**M12 MOTORWAY (SSI-9364) – ENVIRONMENTAL IMPACT STATEMENT (EIS)**

Council at its meeting of the 19 November 2019 resolved to advise the Department of Planning Industry and Environment (DPIE) that it has the following concerns in relation to the M12 Environmental Impact Statement (EIS).

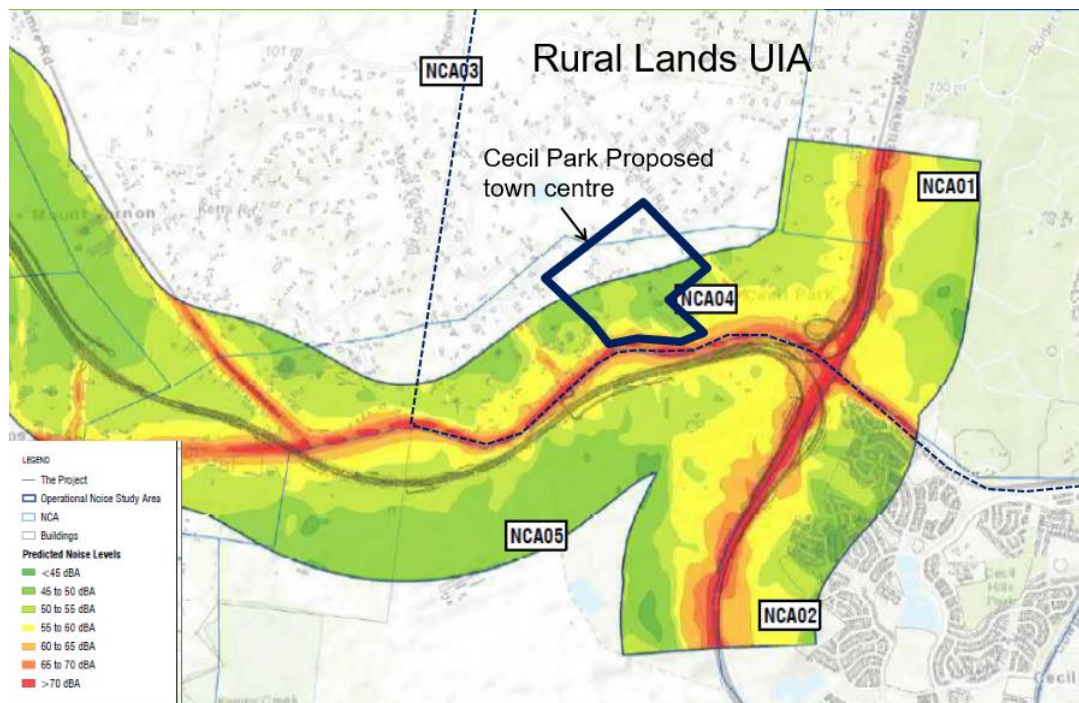
None of the EIS technical reports associated with the M12 proposal make any reference to or undertake an analysis of the impacts of the proposal on the Fairfield/Penrith Rural Lands Urban Investigation Area (UIA,) as identified in the Western City District Plan (image below), comprising the suburbs of Horsley Park, Cecil Park and Mount Vernon. Rather these areas are treated as rural lands.

The lack of regard to the UIA and draft preferred Structure Plan is considered a significant flaw in the EIS as it fails to examine both the cumulative impacts of the proposal on the future population of the UIA, as well as the implications of traffic generation from the UIA on the M12 and associated road network providing access to the motorway.

Extract from M12 EIS – Noise impacts 2036

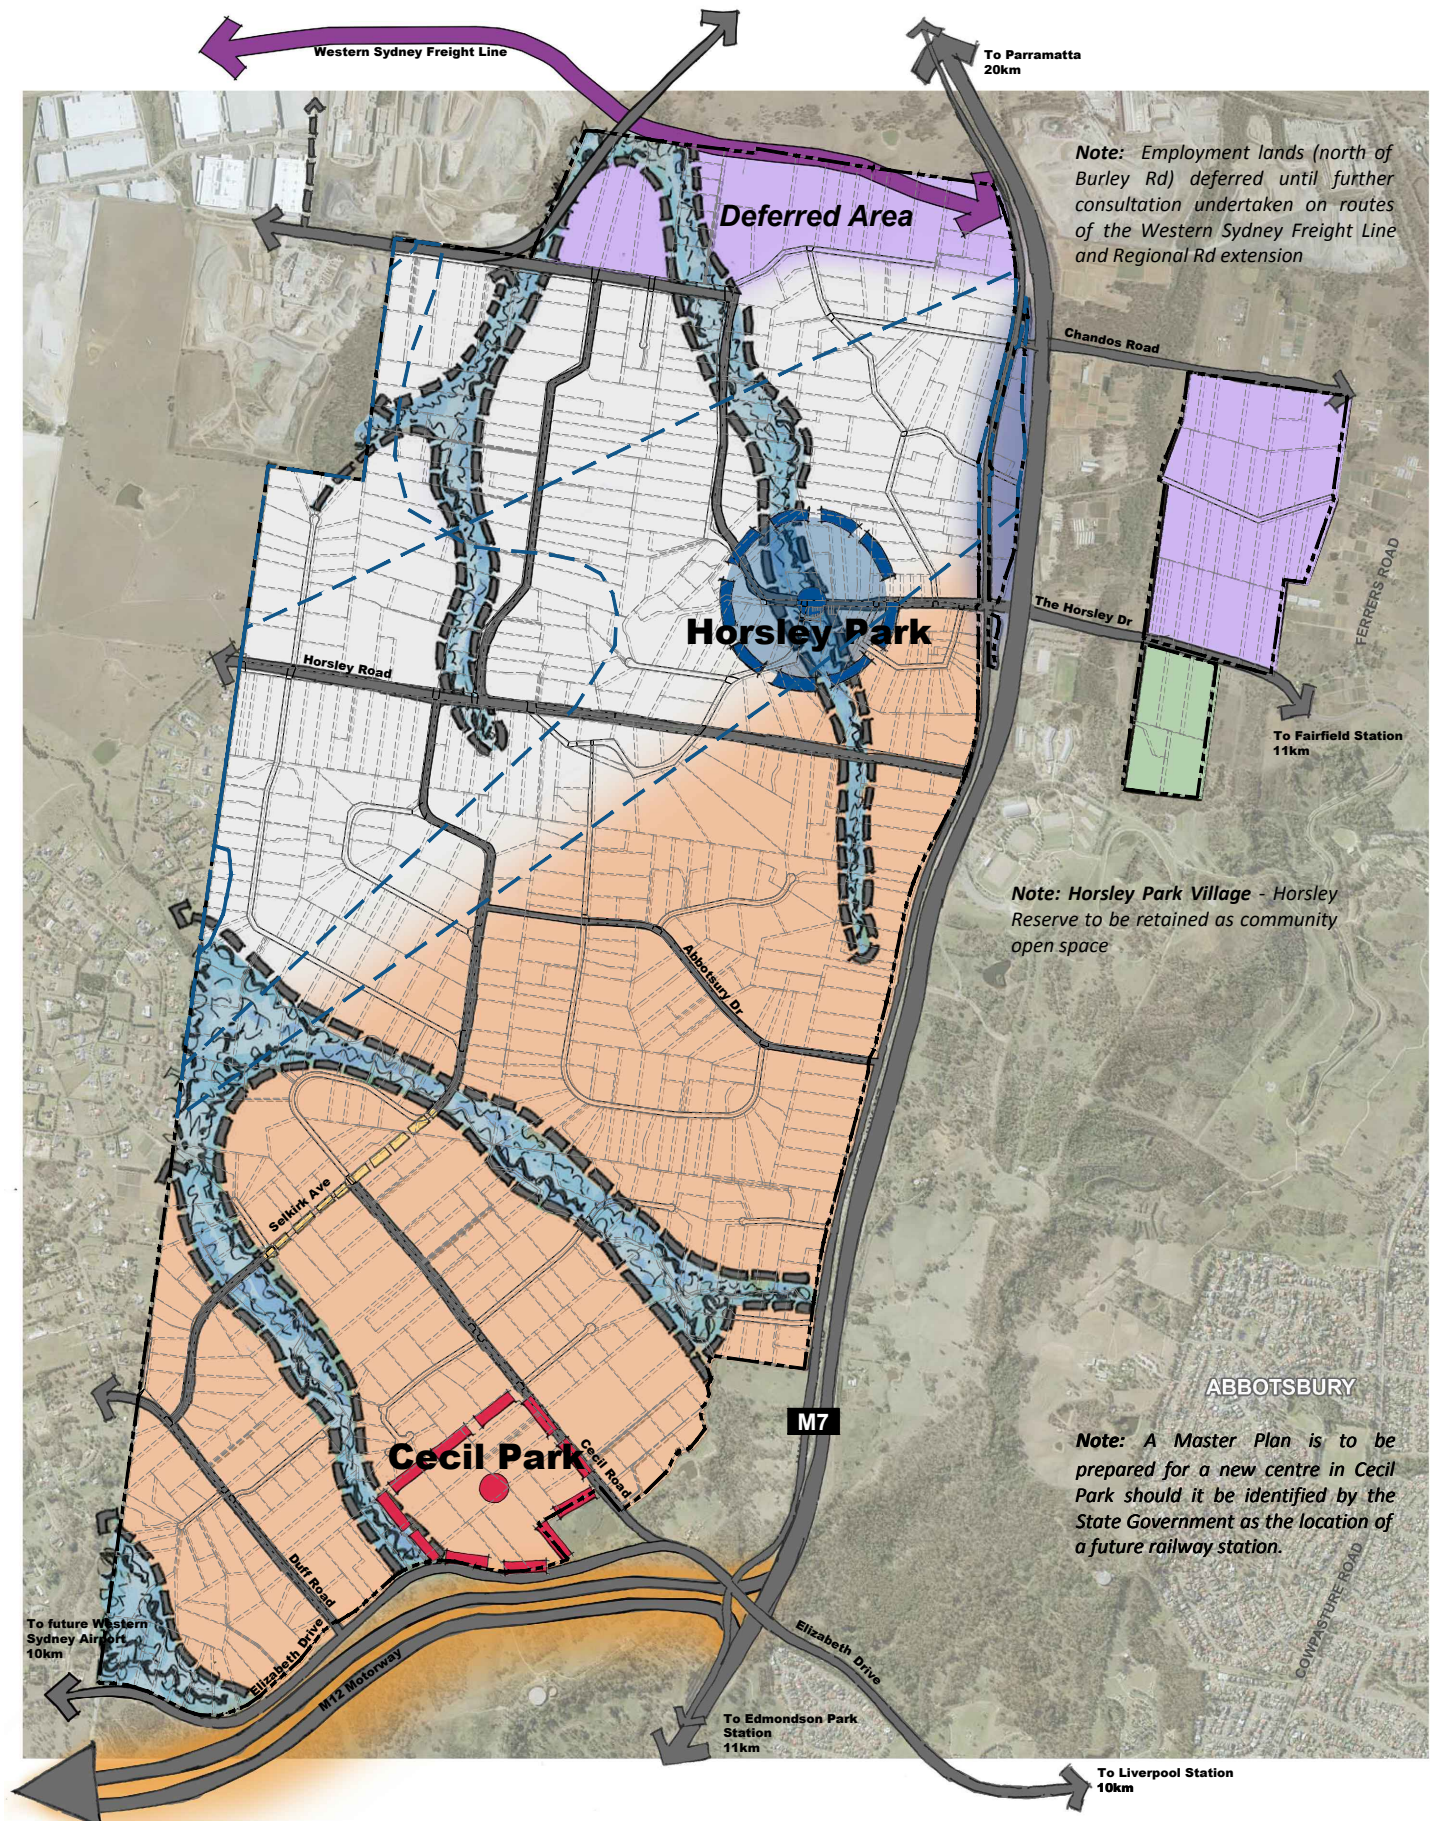
Information included in the EIS (image below) indicates the location of the proposed town centre in Cecil Park would be highly impacted by traffic noise associated with operation of the M12 corridor that would reach levels of between 40-60dba at night-time by 2036.

A major source for traffic noise levels will be from heavy vehicles supporting the 24 hour freight operations of the WSA. The traffic noise levels from the M12 would significantly compromise the amenity of the potential town centre that would support higher residential densities if a railway station was provided at Cecil Park.

This fact is not acknowledged in the EIS that treats the locality as rural lands and does not consider the constraints created for potential future high density residential development in the area. This includes the need for mitigation measures both in design of the M12 (including noise attenuation measures) and implications for the design and layout of the potential Cecil Park Town Centre.
